The following pages replace and supplement the existing pages behind the Enclosure 2 tab for Chapter 3.3, Volume 3.

3/4.3.1 RTS INSTRUMENTATION

VEGP ITS Conversion Enclosure 5 - Justifications for Differences from NUREG-1431 Chapter 3.3 -Instrumentation

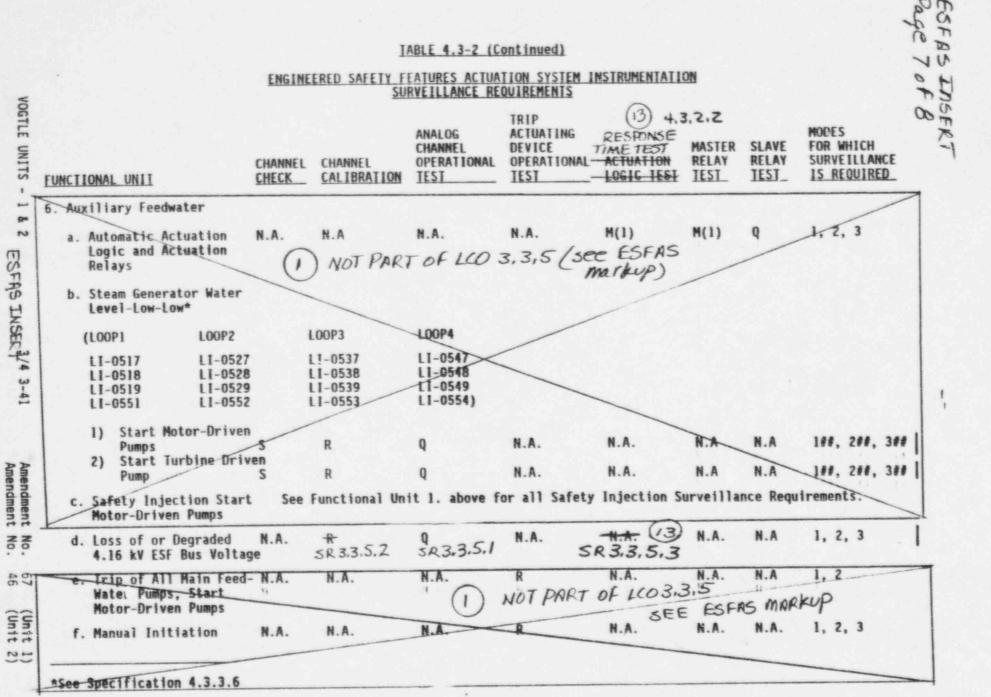
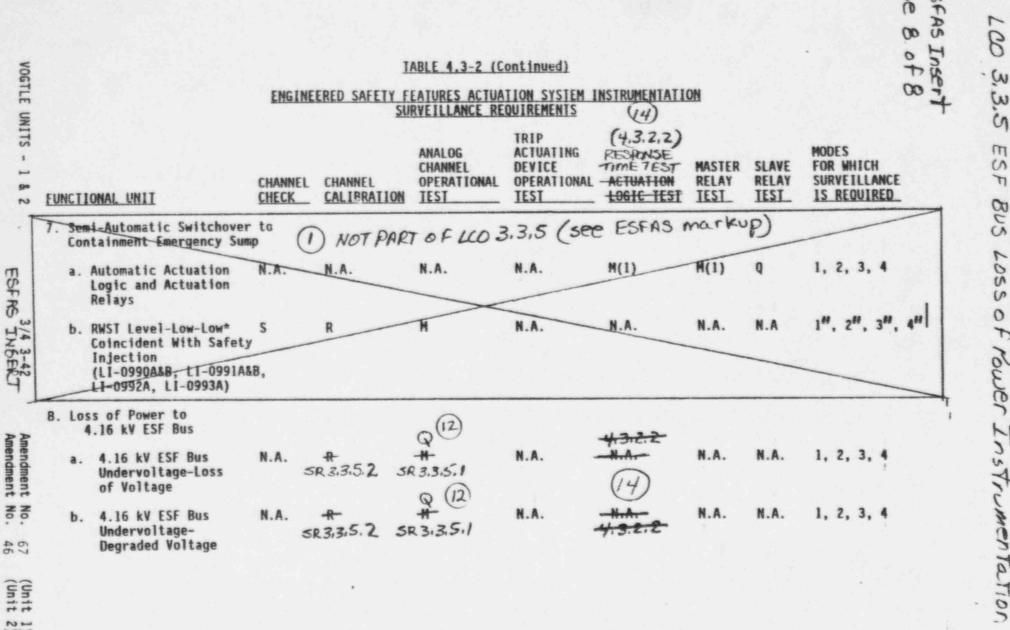
The Notes affecting the Turbine Trip functions are incorporated into VEGP ITS SRs 3.3.1.14 and 3.3.1.16 and their associated frequencies, consistent with NUREG-1431. In addition, the frequency for the low fluid oil pressure turbine trip function is revised to be consistent with the applicability for this function (above P-9 or 50 % RTP). The TS require that surveillances be performed prior to the Mode of Applicability. The current TS frequency of this surveillance "S/U" (meaning reactor startup) does not clearly state the performance requirement for a function with an applicability of above 50% RTP. Therefore, the frequency of the corresponding VEGP ITS SR 3.3.1.16 is revised to "After each Mode 3 entry for unit shutdown and prior to exceeding the P-9 interlock trip setpoint." This revision is intended as a clarification and is consistent with the intent of the original surveillance frequency and with the Applicability of the instrument function (above P-9). Therefore the revision of this frequency is considered an administrative change.

51 A The VTS Note 4 to exclude neutron detectors from the Channel Calibration is incorporated into the ITS SR 3.3.1.11. This change is considered administrative and is consistent with NUREG-1431.

> A The VTS Note 7 that modifies the frequency of the applicable surveillances, is incorporated into the frequency for ITS SR 3.3.1.4 and SR 3.3.1.5. In addition, since the definition of Staggered Test Basis has been revised the test frequency is now stated as 31 days on a staggered test basis instead of 62 days on a staggered test basis. The actual test frequency for a given channel is not changed. Only the definition of staggered test basis has changed. This change is considered administrative and is consistent with NUREG-1431.

Table 3.3.7-1 (page 1 of 1) CREFS Actuation Instrumentation

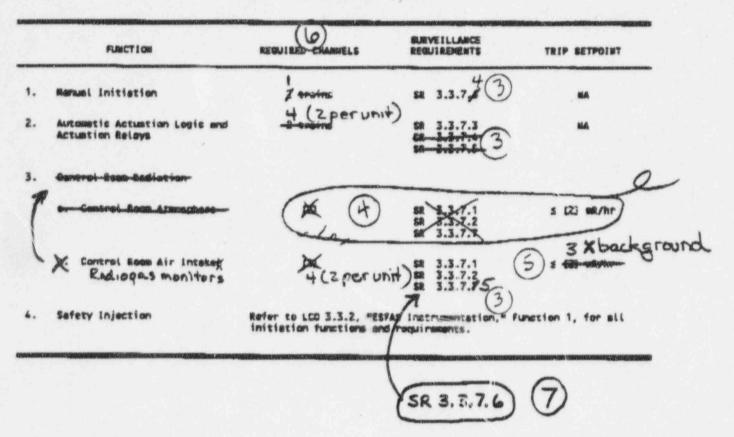
CHANGE NUMBER	SHE		
		with the requirements of the NUREG-1431 LCO that now contains the setpoints.	
32		Not used.	
33	A	A specific SR is identified for Response Time Testing of the Control Room Emergency Filtration Function. This addition of a specific surveillance requirement for Response Time Testing is consistent with NUREG-1431 as the generic surveillance requirement of the current ESFAS TS for Response Time Testing is not used in the NUREG- 1431 format. Each instrument function has the required surveillances identified.

A VEGP specific SR for response time testing the radiogas monitor actuation instrumentation has been added to the Improved CREFS TS. The radiogas monitors are required to actuate CREFS for a fuel handling accident in the fuel handling building. The analysis associated with this postulated event assumes a response time which includes the radiogas monitor actuation. The CREFS radiogas monitors are specified in the current VEGP ESFAS TS which has a surveillance requirement for response time testing. The addition of this SR to the Improved CREFS TS is consistent with the surveillance requirement (4.3.2.2) in the current VEGP ESFAS TS. The following page replaces the corresponding page behind the Enclosure 4b tab for Chapter 3.7, Volume 6. NOU-06-1995 12:24 FROM VOGTLE TECH. SUPPORT

and the same of th	SURVEILLANCE	FREQUENCY
SR 3.3.7.3	Perform ACTUATION LOGIC TEST.	31 days on a STAGGERED TEST BASIS
5R 3.3.7.4 1 ^{/B} veg?		21 days on a STAGGERED TEST BASIS
67 3.5.7.9	N/A VEGP	- { 82} days -
4 SR 3.3.7.∮	VERIFICATION OF DEPROINTIS NOT REGUINED.	2188 months
SR 3.3.7.X	Perform CHANNEL CALIBRATION.	a 180 months
SR 3.3.7.6	Verify ESF RESPONSE TIME for radio- gas monitors within Limit.	18 months on a staggered test basis.
	(7)
